WILLIAMSON COUNTY, TEXASCHANGE ORDER NUMBER: 19

Contractor: James Construction Group ☒ Yes ☐ NoProject Name: FM3349 at US 79Change Order Work Limits: Sta. 503+00 to Sta. 536+00Type of Change(on federal-aid non-exempt projects): Minor (Major/Minor)Reasons: 1A (3 Max. - In order of importance - Primary first)

**FM3349 at US 79
Williamson County Project No. 22IFB139**

Change Order No. 19

FM 3349			
SUMMARY OF QUANTITIES			
SHEET 13 OF 17			
DESIGN	FED. RD. CIV. NO.	FEDERAL AID PROJECT NO.	HIGHWAY NO.
GRM	6		FM 3349
GRAPHICS	STATE	DISTRICT	SHEET NO.
GRM	TEXAS	AUS	31
CHECK	CONTROL	SECTION	JOB
PKD	3486	01	008, ETC

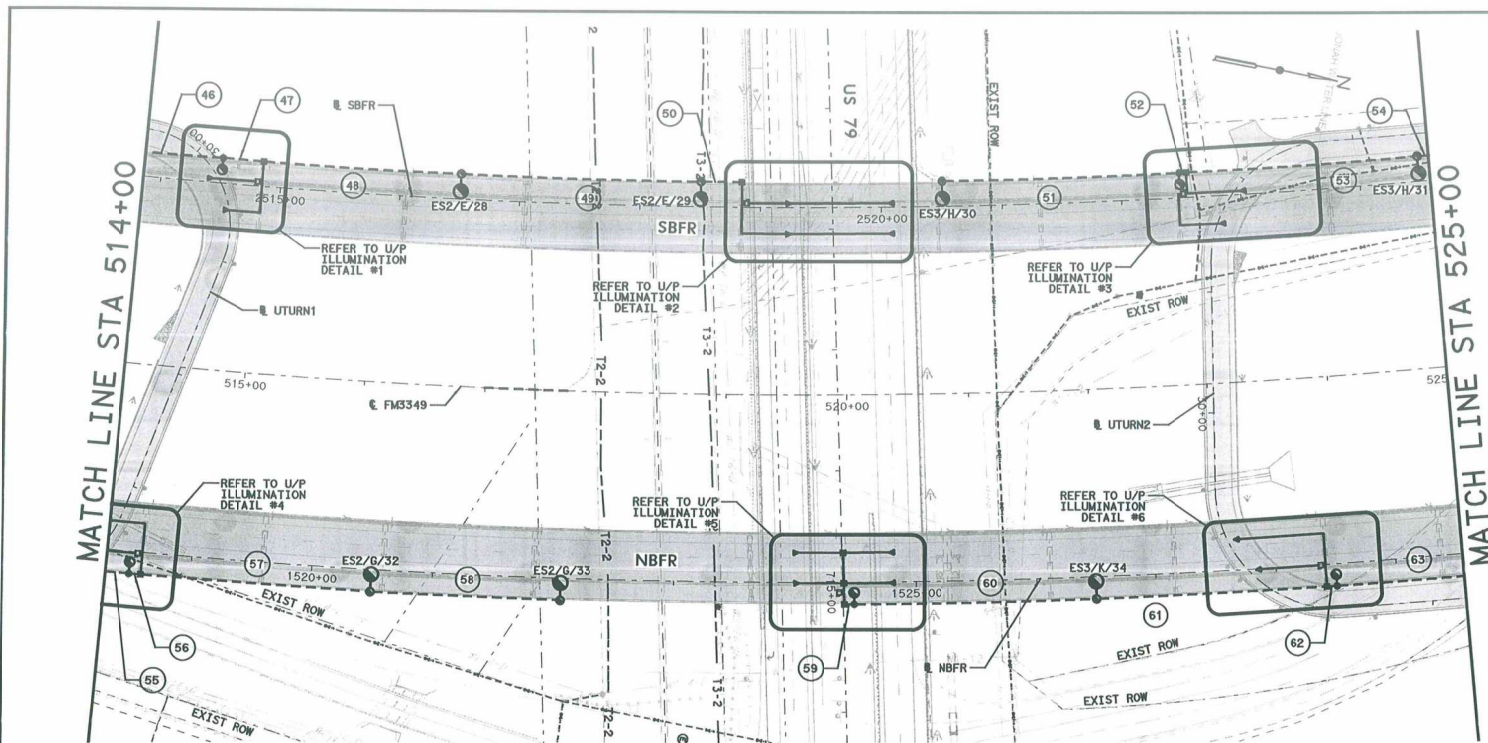
1. Design Error or Omission. 1A Incorrect PS&E : This Change Order compensates the Contractor for replacing the bridge blister anchor bolts for the illumination poles on the northbound and southbound bridges. The as-bid plan set specified the incorrect type of base plate and anchor bolts for the bridge mounted poles. The Contractor submitted an RFI proposing to use the specified base plates with the correct type of anchor bolts. The Engineer of Record (EOR) reviewed the request and agreed with the Contractor's proposal. As a result of this change, 27 previously approved and fabricated anchor bolt sets, will be replaced with the correct type for the specified illumination poles. The supplier did not give the Contractor the option to pay a re-stocking fee for the original anchor bolts. Therefore, 27 anchor bolts will be delivered to Wilco maintenance yard to be used in future projects.

This Change Order compensates the Contractor for replacing the bridge blister anchor bolts for the illumination poles on the northbound and southbound bridges. The as-bid plan set specified the incorrect type of base plate and anchor bolts for the bridge mounted poles. The Contractor submitted an RFI proposing to use the specified base plates with the correct type of anchor bolts. The Engineer of Record (EOR) reviewed the request and agreed with the Contractor's proposal. As a result of this change, 27 previously approved and fabricated anchor bolt sets, will be replaced with the correct type for the specified illumination poles. The supplier did not give the Contractor the option to pay a re-stocking fee for the original anchor bolts. Therefore, 27 anchor bolts will be delivered to Wilco maintenance yard to be used in future projects.

RFI Detail:
I have noticed error in the bid item description for the illumination poles that need clarification: There is an error in the bid item description for the illumination poles. The 27 poles that are listed as "IN RD II (TY SA) 40S are "S" base poles, these are mounted on concrete foundations without a "T" base (mostly behind guard rail). The description should have read "IN RD IL (TY SA) 40B for bridge blister or retaining wall poles. See Below the 2 differences: 1. Anchor Bolts, the poles have a separate set of anchor bolts listed in the bridge details "BL". 2. Handhole height ATS mention that they don't see many blister poles with the correct handhole height, but we do need the correct anchor bolts (to attach the S base poles to the blister). Please let me know if the engineer is going to require the correct poles (B base), or will the correct anchor bolt with the S base poles be sufficient? We do have the S base poles materials on MOH.

IN RD IL (TY SA) 40S ("S" base) type poles have the same anchor bolt plate size, anchor bolt circle diameter size, and anchor bolt hole diameter size as IN RD IL (TY SA) 40B ("B" base) type poles required for bridge illumination pole brackets (BL standard) and retaining wall light pole brackets (RW-LB standard). Contractor to utilize the (27) IN RD IL (TY SA) 40S ("S" base) type poles the contractor already has MOH for all illumination poles mounted to bridge light pole brackets (BL standard) and retaining wall light pole brackets (RW-LB standard). BL and RW(LB) standards are located within the project plan set. Provide the correct anchor bolts only, per the BL bridge light bracket standards and RW(LB) retaining wall light bracket standards, for the (27) IN RD IL (TY SA) 40S ("S" base) type poles contractor already has MOH. GM@HDR.
